Docket Item # 3
BAR CASE #2011-0362

BAR Meeting
January 18, 2012

ISSUE: Certificate of Appropriateness

LOCATION: 400 N Union Street

Figure 3: N Union Street façade.

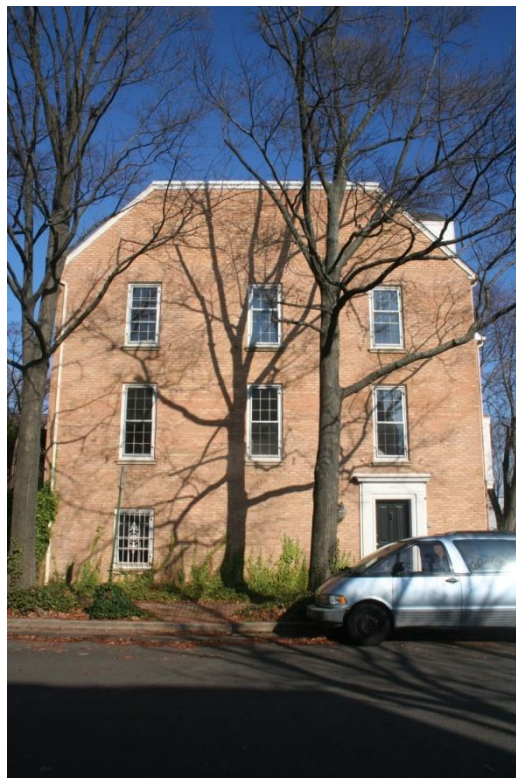
are proposing to turn the three individual dormers on the front into one large Palladian style dormer with 2'-2" x 4'-0" clad casement windows. The *Design Guidelines* state that "dormers should align with the existing windows or be centered between the windows." Historically, "dormers are generally tall and narrow with minimal trim at the sides of the windows." Staff recommends the denial of the Palladian dormer on the front façade, as the existing dormers are of the appropriate design, scale, and placement. While other Palladian dormers have been incorporated onto the front of these townhouses, Staff feels that continued use of them will have an adverse effect on the development and the view from Founders Park because of the cumulative alteration of the scale of these buildings.

Staff recommends denial of the Certificate of Appropriateness for the dormer on the front (east) façade.
